Re: Department of Buildings Zoning Approval for 200 Amsterdam Avenue, Manhattan

Zoning Challenge
and Appeal Form
(for approved applications)

RE: Zoning Challenge 200 Amsterdam
Block 1158, Lot: 133, Job No:
122887224, Doc. 7

Plan of block 1158 with existing buildings, street addresses, tax and zoning lot lines

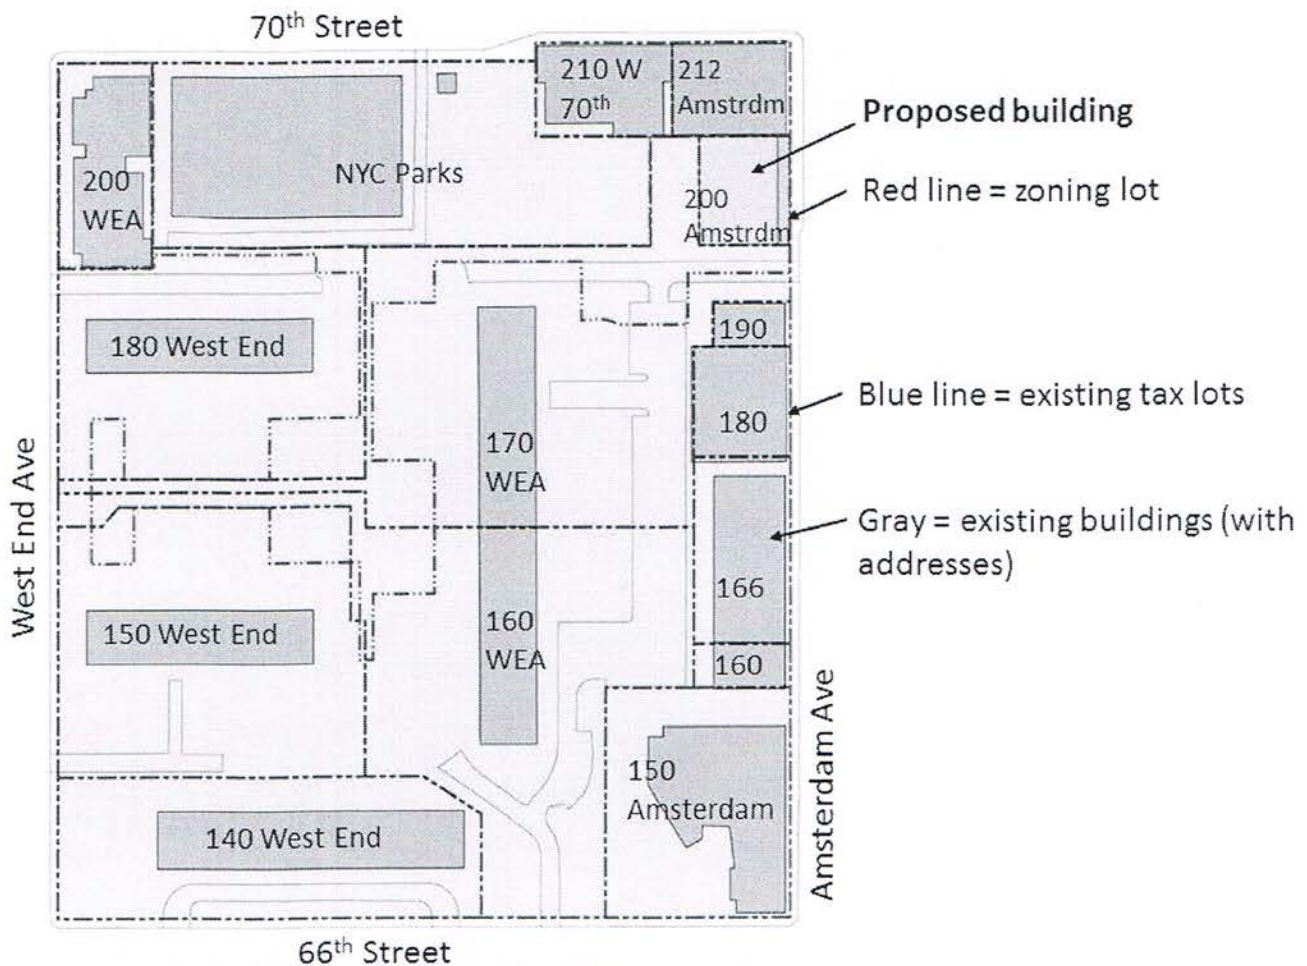
200 Amsterdam is proposed for the northeastern part of superblock 1158 on tax lot 133, which is a 12,042 SF lot, and fronts Amsterdam Avenue. At 55 stories and 668 feet, the building is exceptionally tall for the Upper West Side, and would be the tallest building on the Upper West Side, and the tallest building in New York City north of 61st Street. Despite its height, the building is not a tower according to the Zoning Resolution. Located in an R8 district on a wide street, the height of this building is governed by a sky exposure plane.

It obtains its exceptional height, in part, because ample floor-to-floor heights and large mechanical spaces; building mechanicals are enclosed in the top four floors of the building and are 67 feet tall. Most of its exceptional height, however, results from floor area generated by the enormous size of the irregular zoning lot on which it sits, which is 110,794 SF. The zoning lot is gerrymandered over much of superblock 1158; portions of it front West End Avenue, 70th Street, and Amsterdam Avenue. The zoning lot is partially a corner lot, partially a through lot, and mostly an interior lot.

The oddly shaped zoning lot is not new but was not well-known until recently. An extremely large zoning lot that included most of the superblock was created on the site in 1987. According to my office's research, the first gerrymandered lot was developed in 2007 and amended at least one time in 2016.

*Areas covered by the 1987 zoning lot classified by use of land (with 200 Amsterdam shown as constructed).
Gerrymandered zoning lot of 200 Amsterdam and 200 West End Avenue shown in red*

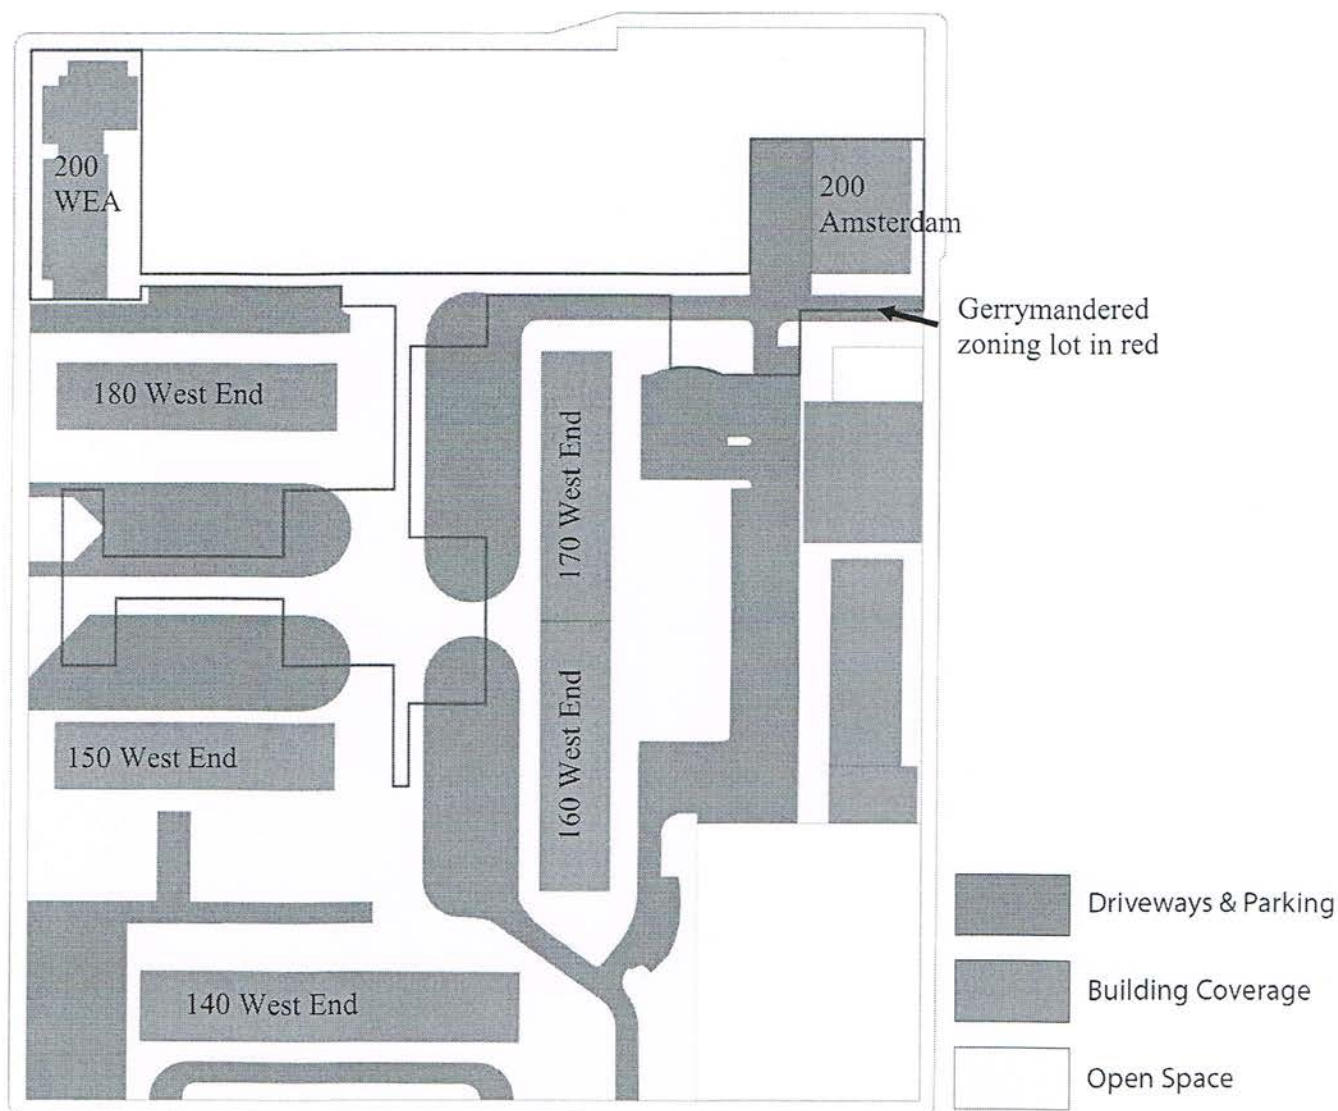
As stated in the Zoning Resolution, up to 50% of the required open space may be accessory parking, driveways, loading docks and bike parking. These uses are shown in gray above.

By my office's calculations, 33,983 SF of the open space on the gerrymandered lot is used for driveways and parking. According to 12-10, an Accessory use:

The parking and driveways are accessory to the uses on the Lincoln Towers zoning lot. They are not accessory to the uses on the gerrymandered lot since there is no parking provided for 200 Amsterdam or 200 West End Avenue. Uses accessory to another zoning lot are not permitted obstructions in Open Space, and thus, the 33,983 SF cannot be counted as open space in 200 Amsterdam's zoning calculations.

The sky exposure plane proposed for 200 Amsterdam. The top four floors break the sky exposure plane.

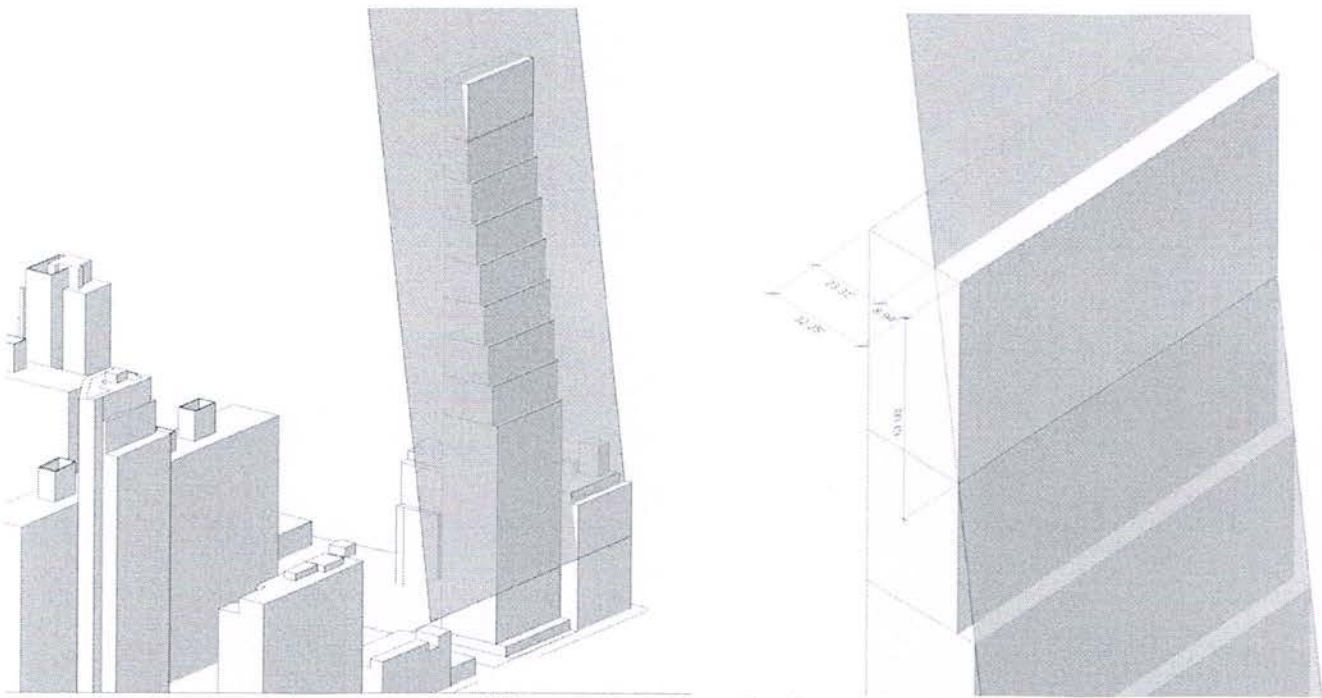
Section 23-62 (g) details what mechanical equipment may be a permitted obstruction in the height and setback of the building. The allowable permitted obstructions are:

The ZD1 states, in effect, that the mechanical equipment located in floors 51 through 55 are permitted obstructions under 23-62(g). The question as to if the in-building mechanical floors may penetrate the sky exposure plane as a permitted obstruction hangs on the definition of “enclosures.” Unfortunately, this is not a defined term in the Zoning Resolution, but the applicant claims, and the Department has agreed, that enclosures may mean exterior building walls. This interpretation is in error, however, as it is not consistent with the New York State Multiple Dwelling Law (MDL).

While it is not a defined term in the MDL, the expression “superstructure” is used here, and elsewhere in the MDL, to refer to a structure that is on top of a building. The obvious interpretation of the MDL is that building height is measured to the top of the roof, with fairly wide exceptions for rooftop mechanicals, parapet walls and the like. The less obvious--and I would say incorrect interpretation--is that the first 50 feet of mechanicals can be exempted from building height. Either way, at 67 feet, the top four mechanical floors break the prescribed sky exposure and should not be considered permitted obstructions to maintain consistency with the MDL, as required by law.
